# PLANNING, PRESERVATION, & ZONING

Your application for a Plan Revision to your approved plans at 17 Fremont Street (ZBA 2018-61), case number P&Z22-107, has been deemed *de minimis* and accepted. Please see notes below and attached exhibits.

## PR17 FREMONT STREET RESIDENCE

PROPOSED  
FLOOR PLANS

2 Proposed - Roof Plan  
1/4" = 1'-0"

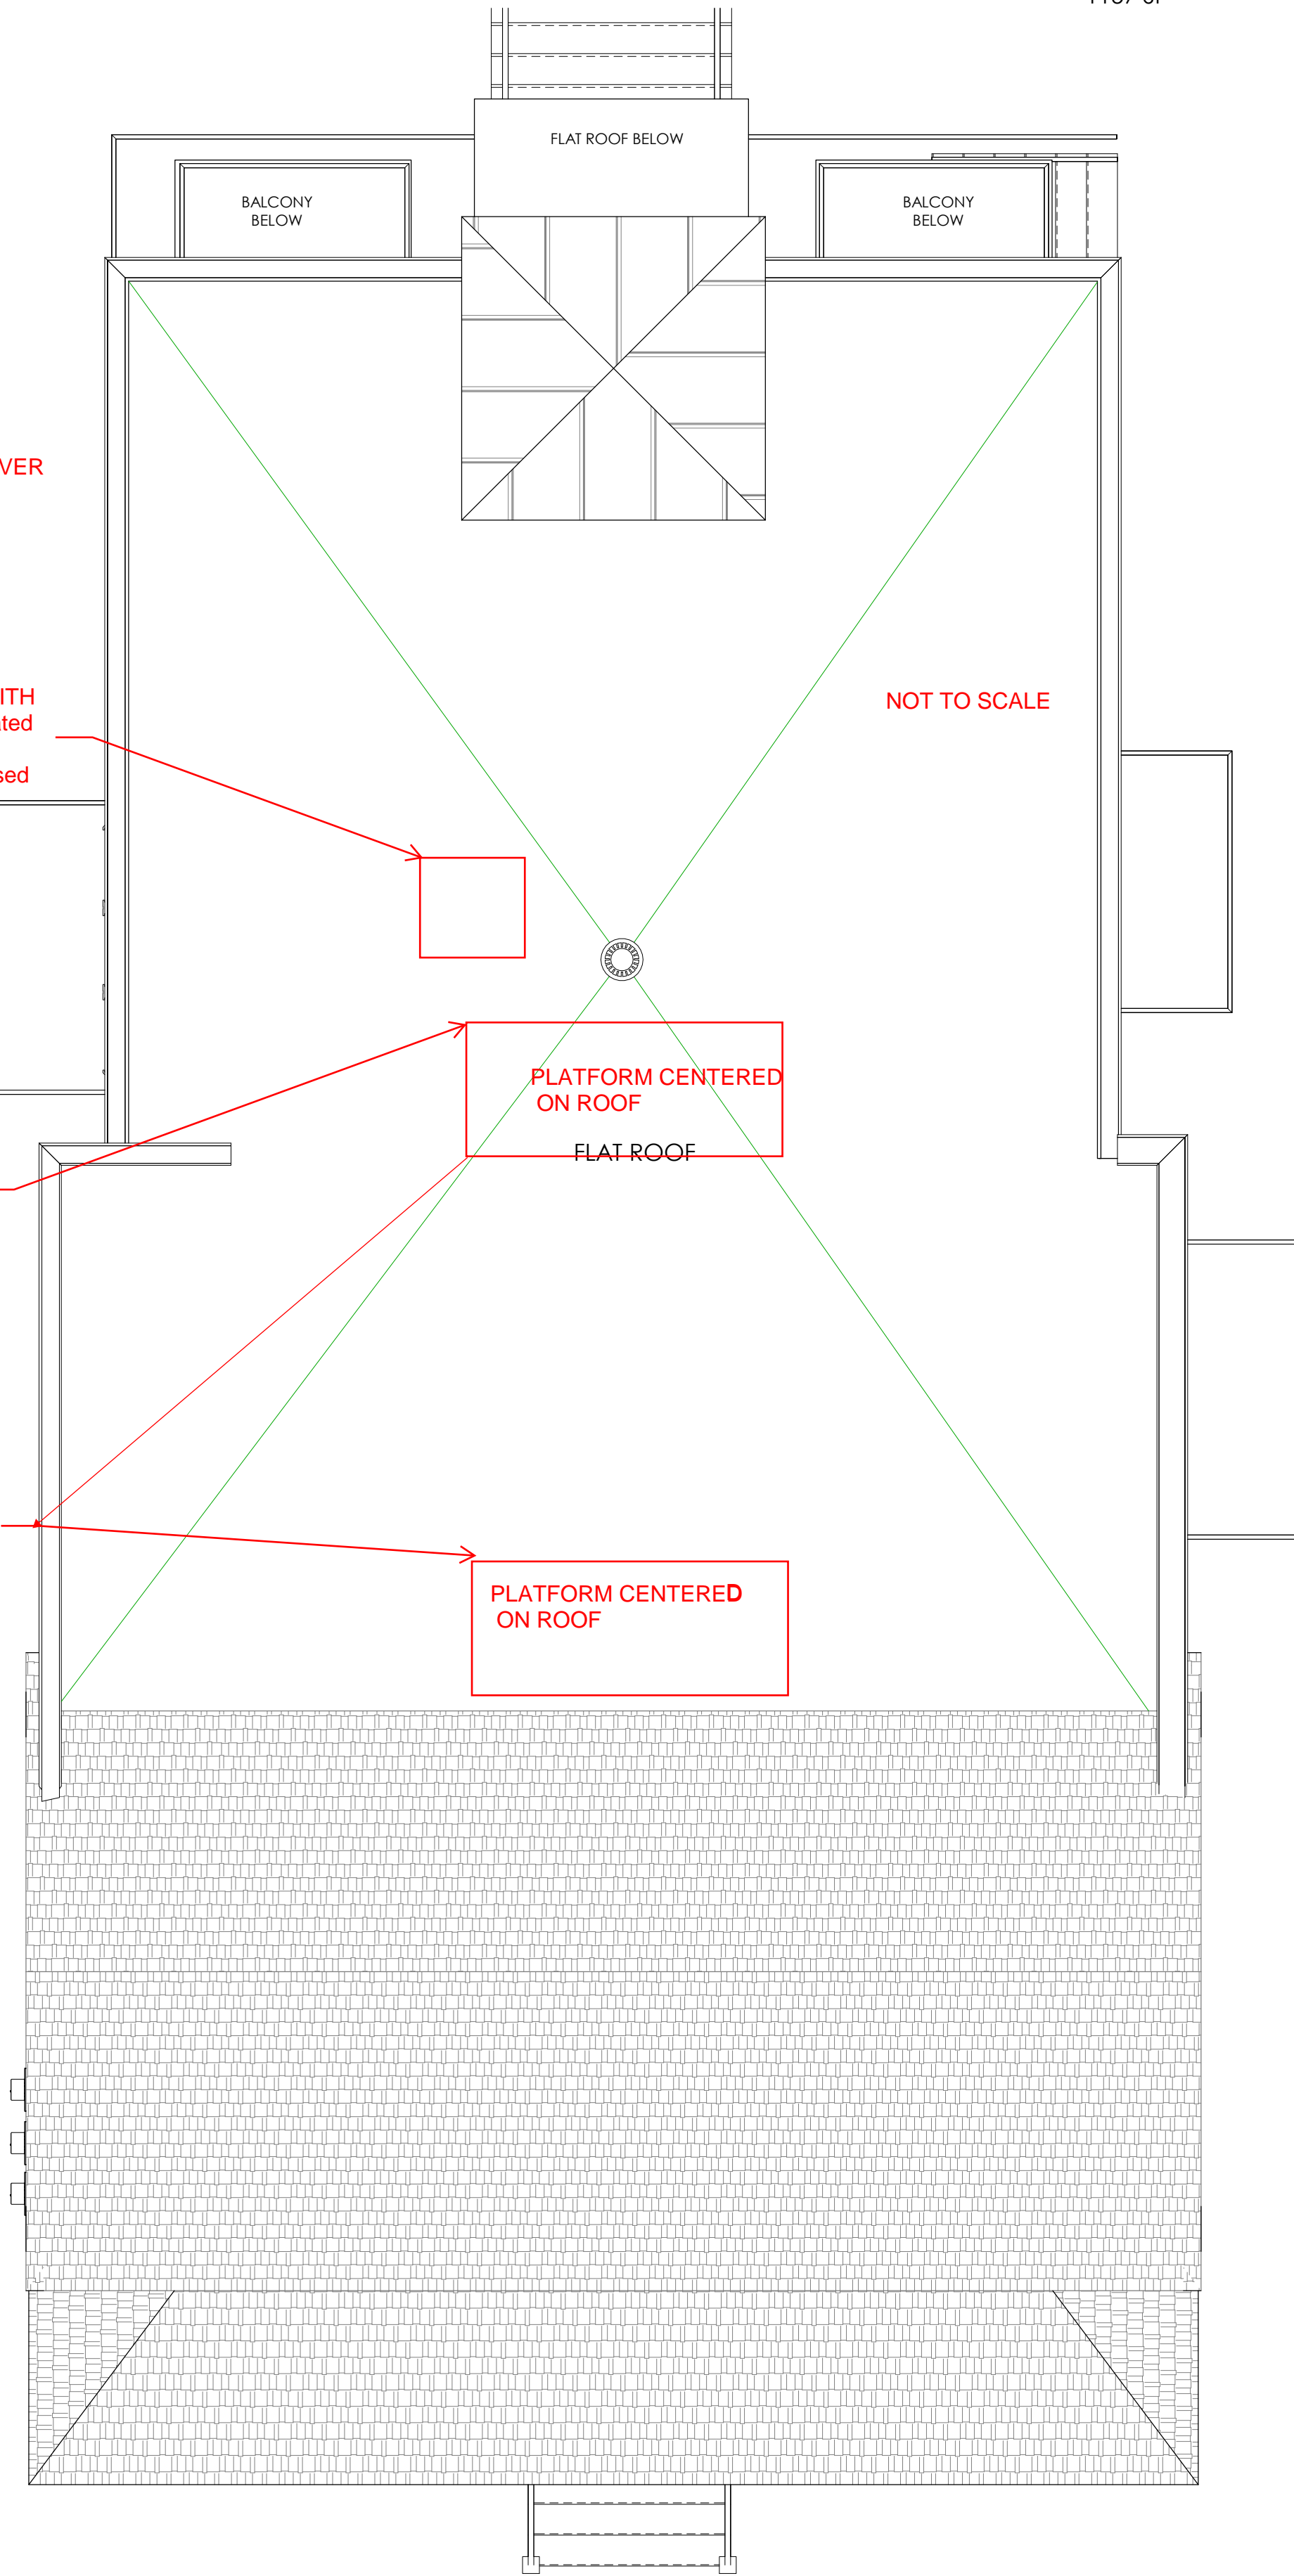
POSITION PLATFORMS  
'CENTERED ON ROOF OVER  
DEMISING WALL

4' X 4' HATCH WITH  
RAIL. Hatch located  
in ceiling of hall  
where we discussed

3' X 10' PLATFORM  
8" MIN. OFF  
FINISHED ROOF  
SURFACE.  
DRAINAGE NEEDS  
TO BE CON  
SINERED

UNITS NEED T O  
AT MIN. 8" OF  
THEFIL
